PLANNING APPLICATION PLN-20-0177

84 & 94 FAIRTLOUGH STREET (APPROVED LOT 13, WILL BE 12 ZIRCON PLACE), PERTH

ATTACHMENTS

**Additional Information Required for Planning Application PLN-20-0177  
Communal Residence at 84 & 94 Fairtlough Street, Perth (on Lot 13 approved by permit PLN-19-0184)**

**SITE PLAN**  
 SCALE 1:200

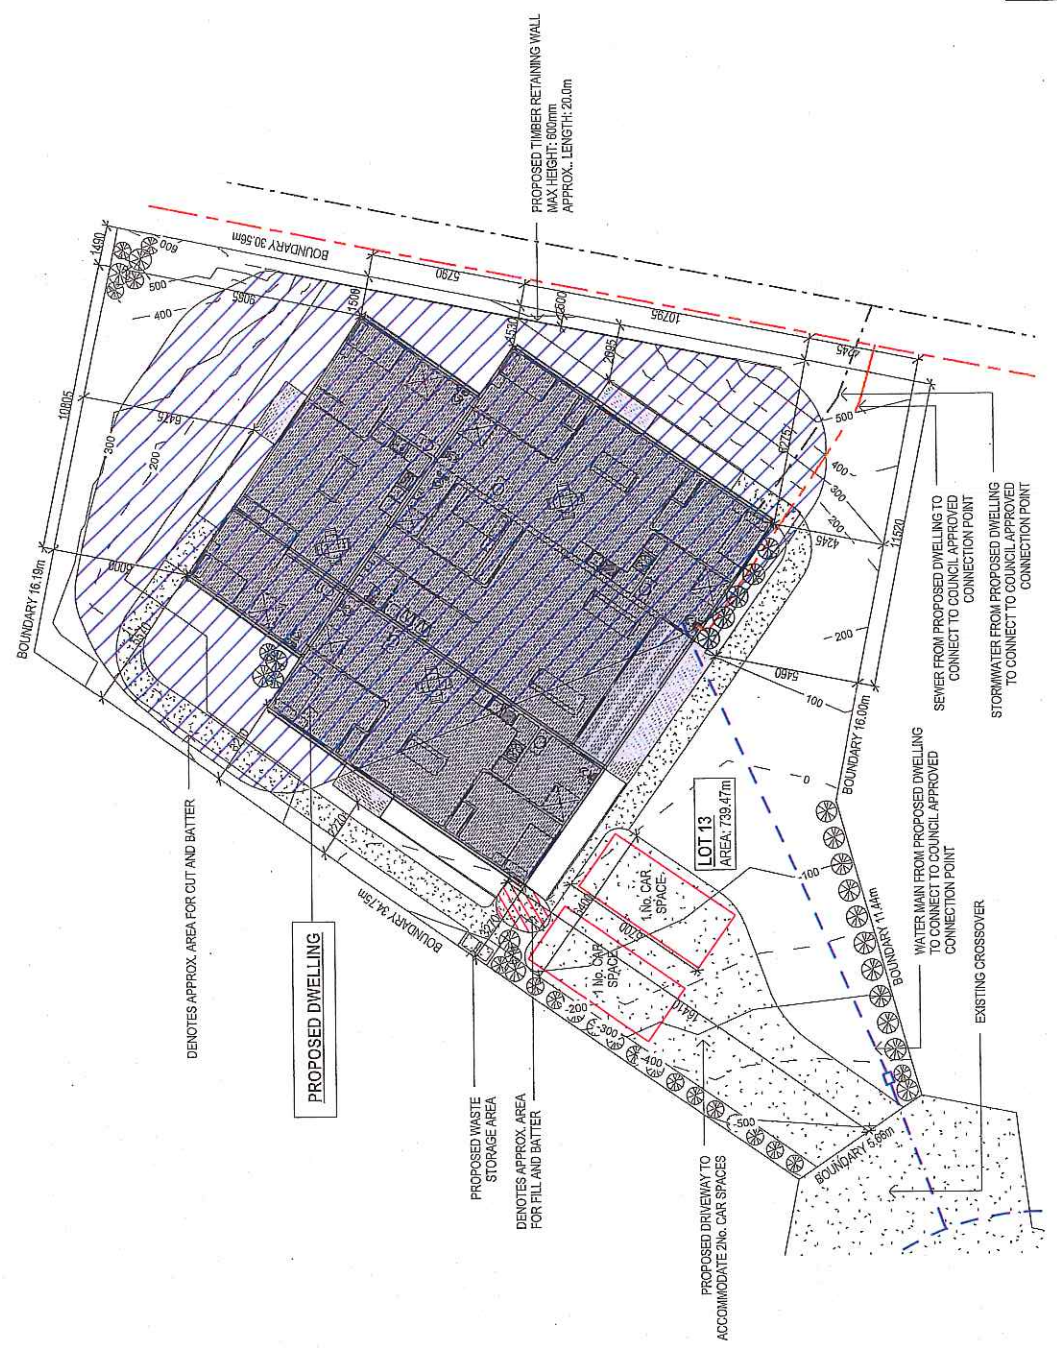
- A copy of the title for Lot 13.
- Plans showing:
  - Landscaping of the site.
  - Any sealed paths.
  - Percentage of the site free from buildings, paving and other impervious surfaces.
  - Waste storage in location(s) not visible from the adjoining cul-de-sac.
  - Parking dimensions.
- A report from an Accredited Bushfire Hazard Practitioner addressing clause E1.4 or E1.5 of the planning scheme.
- A Traffic Impact Assessment from a suitably qualified person addressing the impact of the reduced on-site parking provision on the traffic circulation, safety and efficiency of the surrounding area and whether parking is adequate to meet the needs of the residents of the proposed use having regard to the pattern of parking in the locality.

My argument is that if this was submitted as two x three bedroom units, it would not even make it to planning stage. There is insufficient off street parking for the size of the dwelling, regardless whether the residents are able to drive or not.

We have a contract on Lot 9 Zircon Place. As per the proposal in question, there are only two parking spaces for a minimum of 7 occupants. We purchased in a cul-de-sac for a reason; to have a safe for our children. The excessive amount of traffic this Residence could potentially create, on top of single or multiple dwellings which will be built in this street, in my opinion is far too heavy for a cul-de-sac.

*Hi Laura  
Apart from the 2 Devonfield vehicles per site,  
there will be a max of 2 cars parked for support staff per home between 6am and 10pm.  
But no staff cars overnight.  
Please call if an issue. These houses should be treated like any other family home.  
Please call if you have further questions.  
Regards*

**FLOOR PLAN**  
 SCALE 1:100

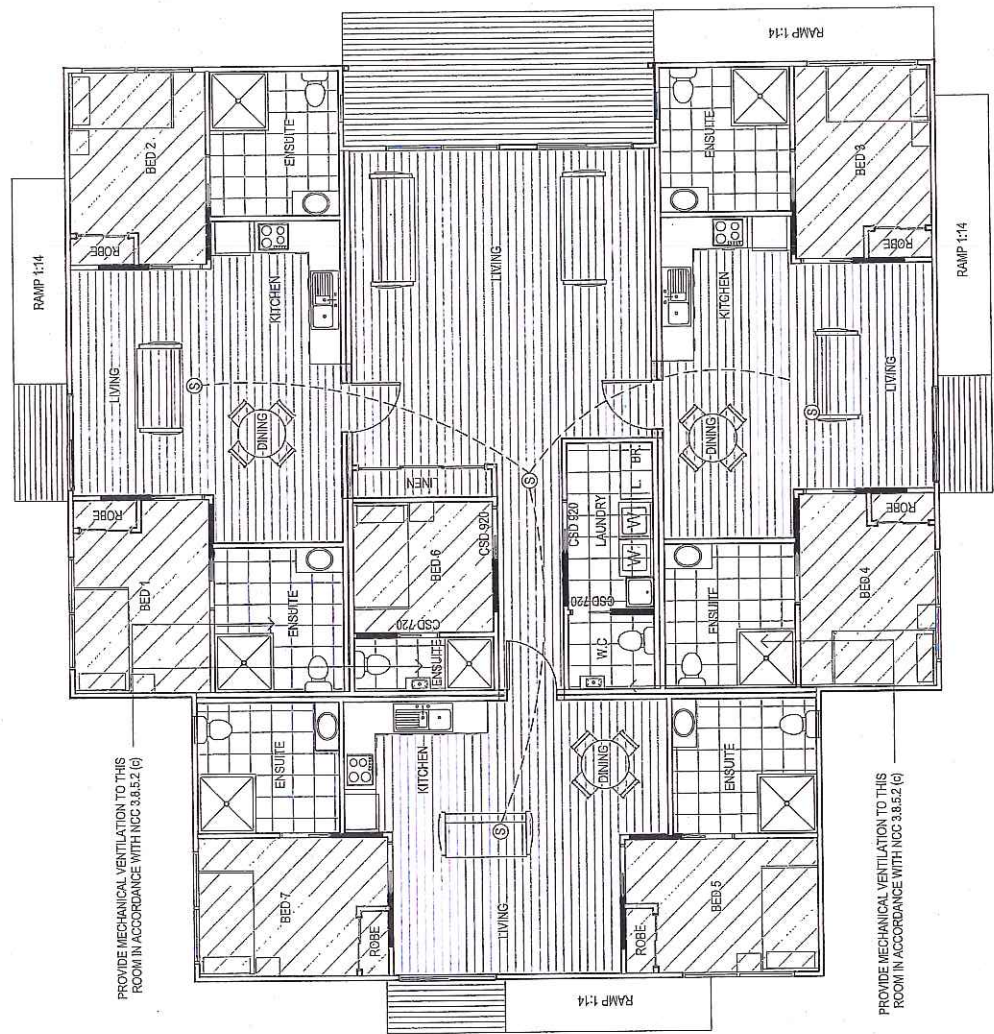
The design of these buildings show that they are of modular configuration and are in fact multiple dwellings joined together. ie: three modules with **each** containing 2 bedrooms, 2 bathrooms a kitchen, dining and living area. Then a central module with a bedroom, living, bathroom and laundry.

This has been a clever design for the owners, which enabled them to avoid multiple dwellings under the planning scheme.

**SOUTH WEST ELEVATION**  
SCALE 1:100

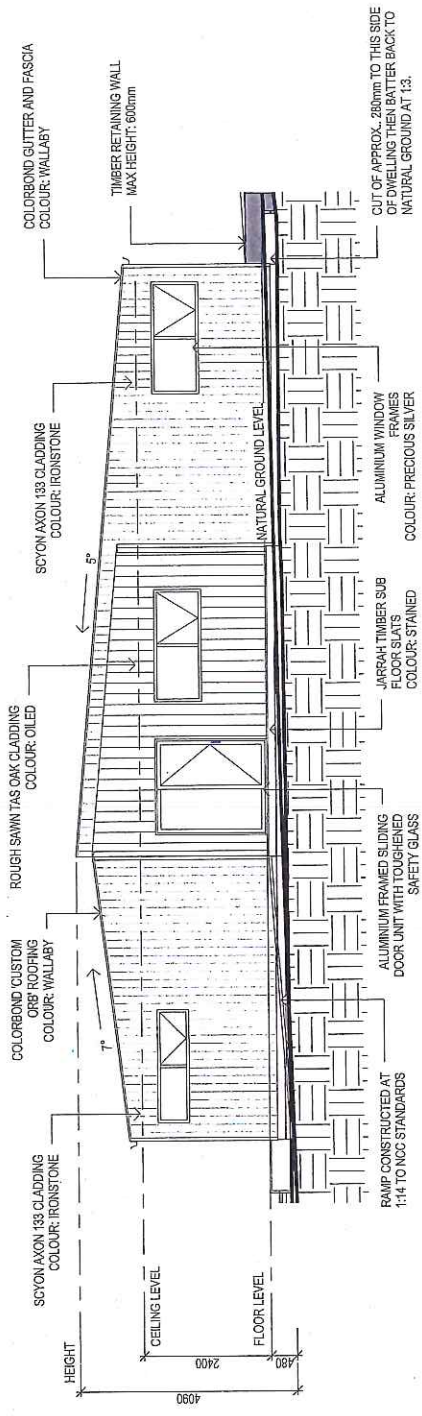
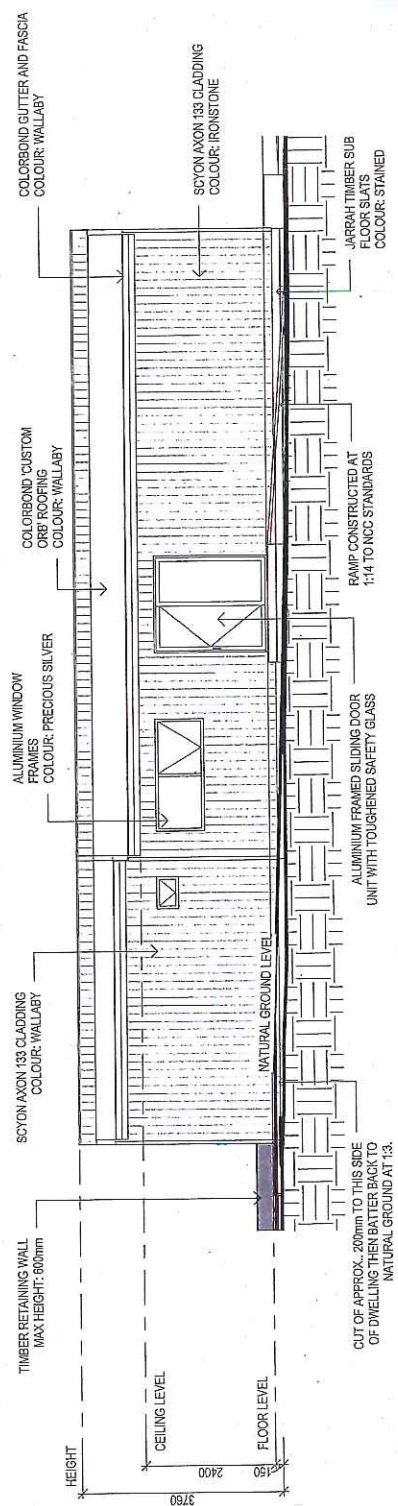
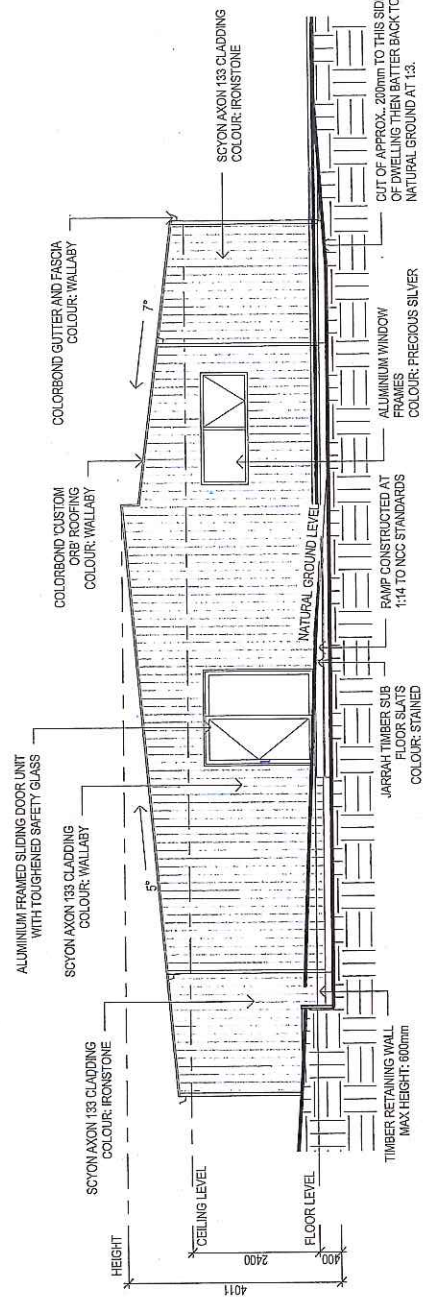
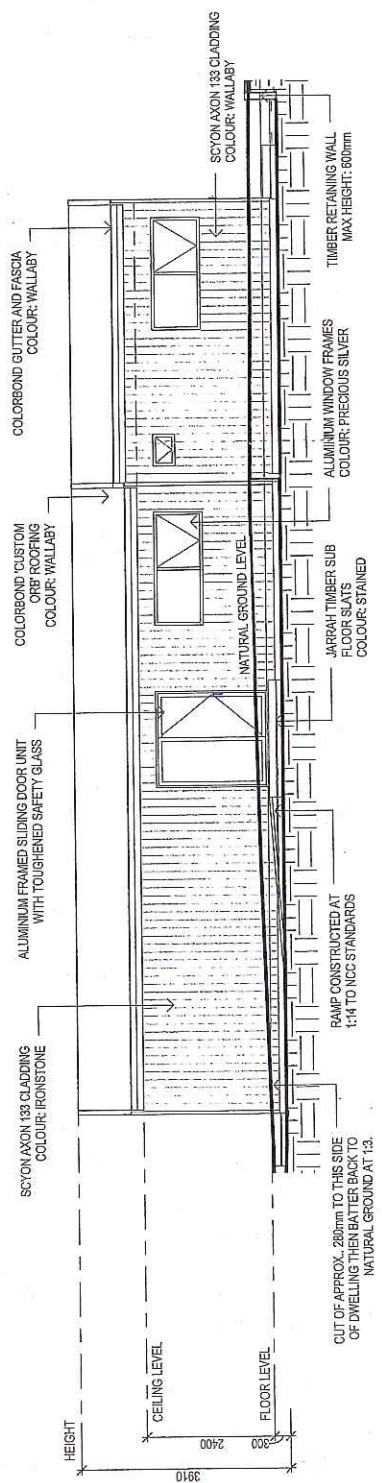
1. 10.3 of the NMC Planning Scheme (Amenity). This building has no appeal whatsoever and will impact and affect values of neighbouring properties. Every new sub-division is wary and frightened of what these designers have actually proposed here. Surely the designers realised this is a new area of Perth and therefore could have designed something a little more appropriate.
